ATI-AQ-004

MODEL: **62**605

**SUBJECT:** Possible Short Circuit

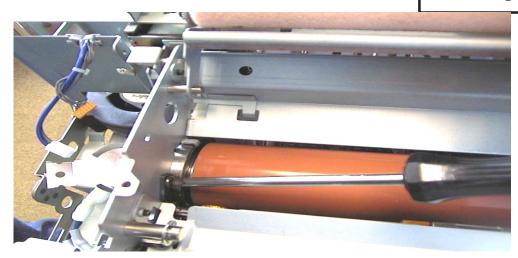
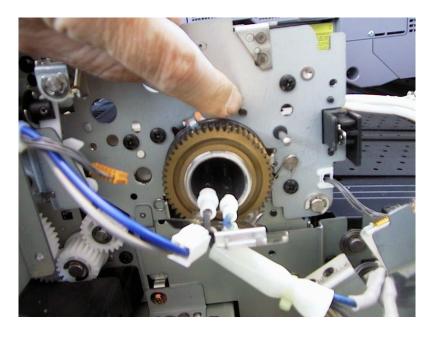
With a screwdriver fitted to the screw (XB1-2400-807), attach the nut (XB7-2100-409) then tighten it. While doing this prevent the screw from turning by holding the screwdriver stationary.

Remove the fixing cleaner belt drive assembly (two screws), this exposes the screw that holds the reciprocating shaft bushing in place.

This screw must be replaced with an 8mm long screw and locked in place with a nut.
